MILITARY SPECIFICATION

CIRCUIT CARD ASSEMBLY: 10547240

(TARGET COUNTER, MEMORY AND READOUT - A4)

This amendment forms a part of Military Specification MIL-C-60579(MU) dated 18 June 1970.

FIGURE 2
EXTERNAL TEST CIRCUITS

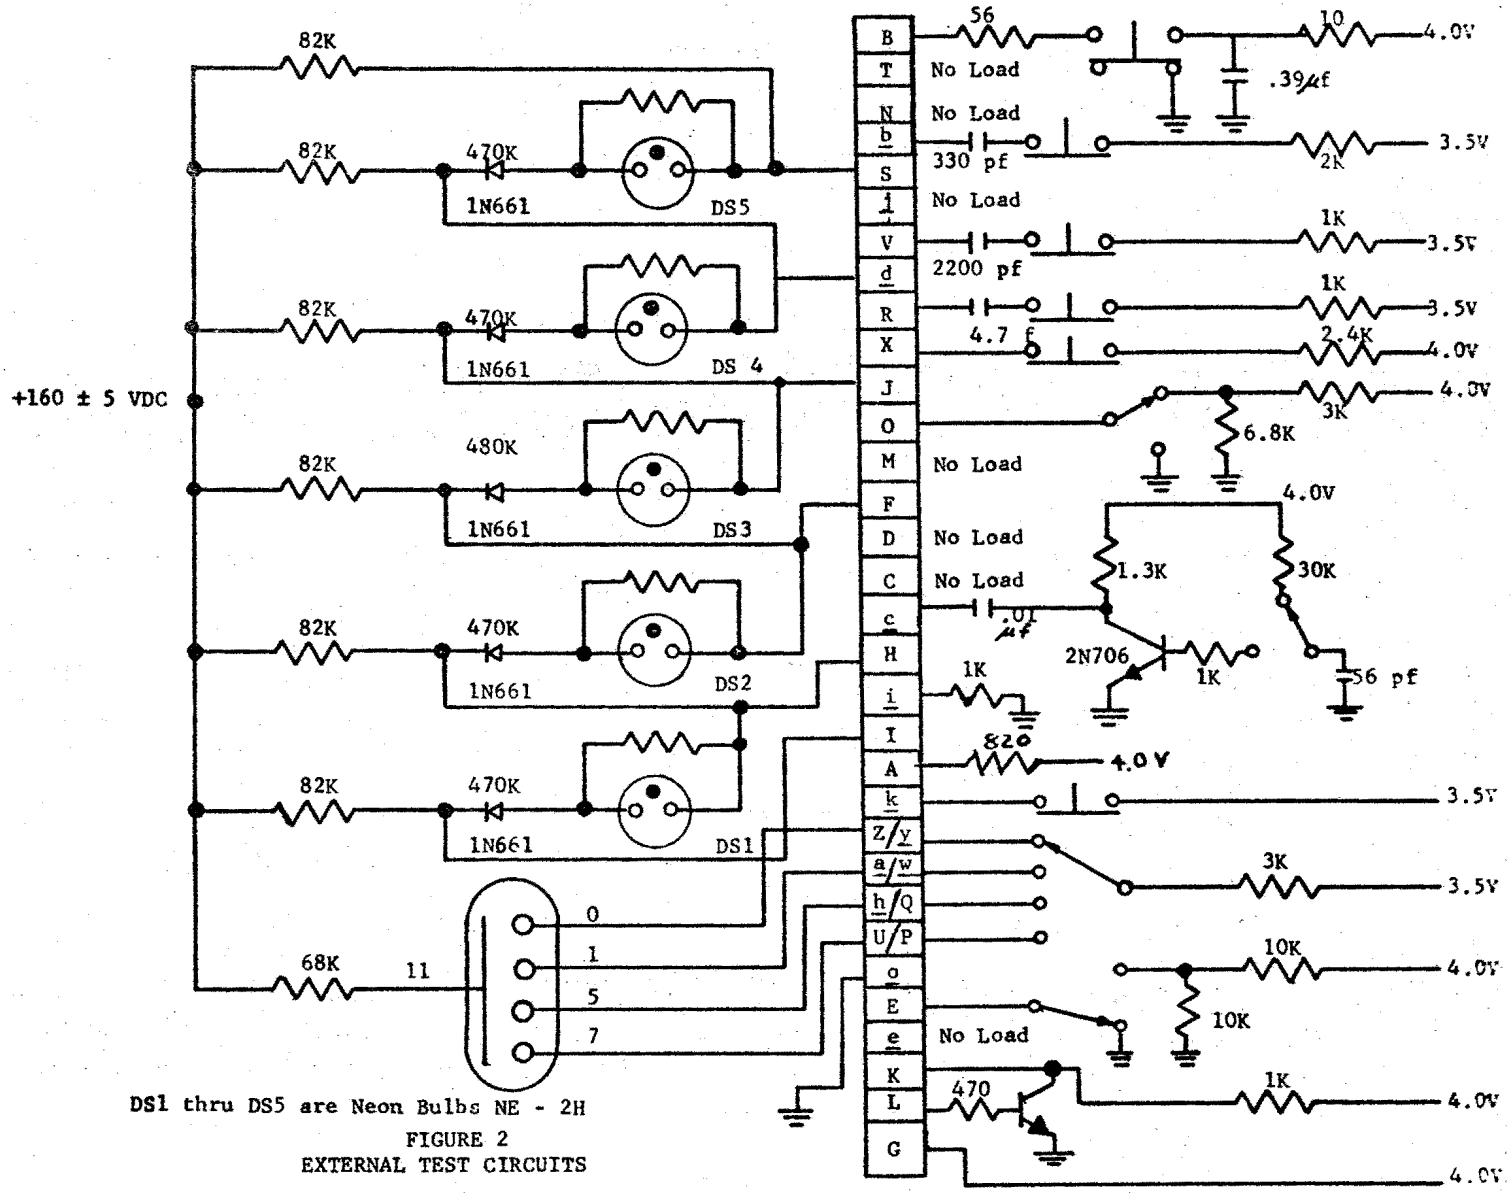
Page 16 Figure 2: Delete and substitute new figure.
